N1092C-01

Modification Recommended Service Note

N1092C DCA-M Sampling Oscilloscope (Single Optical, Dual Electrical Channel)

Figure 1 Updated overlay - should say 1.4 Vpp Max

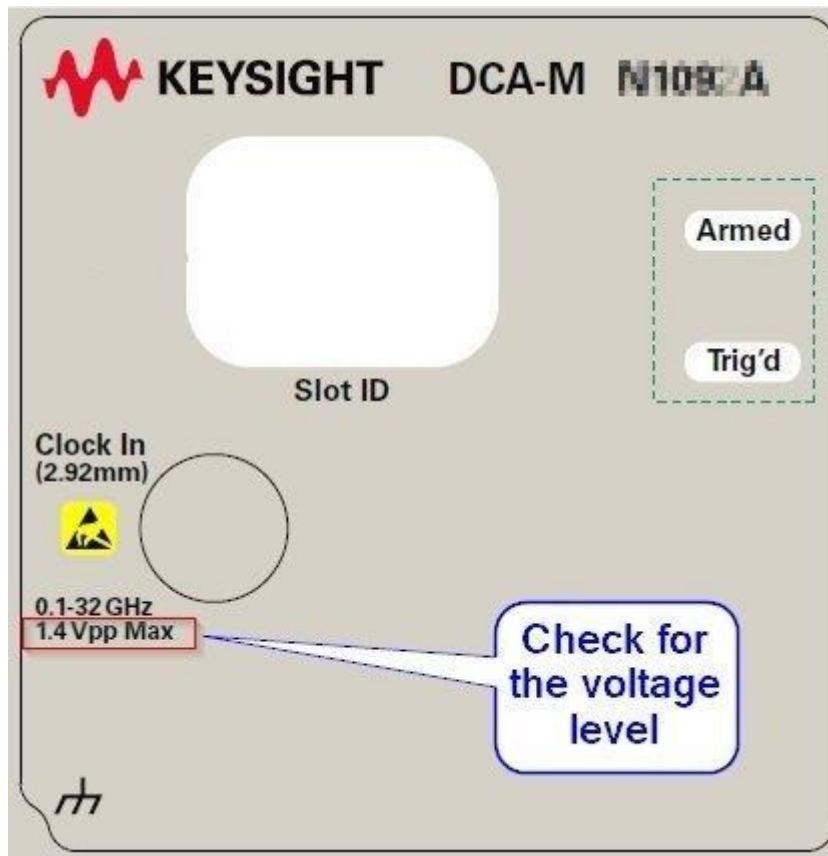
In May 2018, the clock's input port maximum signal voltage changed from 2.0 Vp-p (old value) to 1.4 Vp-p (new value). This is very sensitive circuitry and this change provides additional margin to reduce risk of damage to the instrument.

New instruments shipping after this change has the new left front panel overlay with this updated information, see Figure 1 below.

If the front left panel overlay shows 2 Vp-p (old value), remove the old overlay and replace it with the new overlay that shows 1.4 Vp-p (new value). If the customer has added any asset tags, or other customer information to the old left front panel overlay, it is recommended to send back the old overlay to the customer after it has been removed.
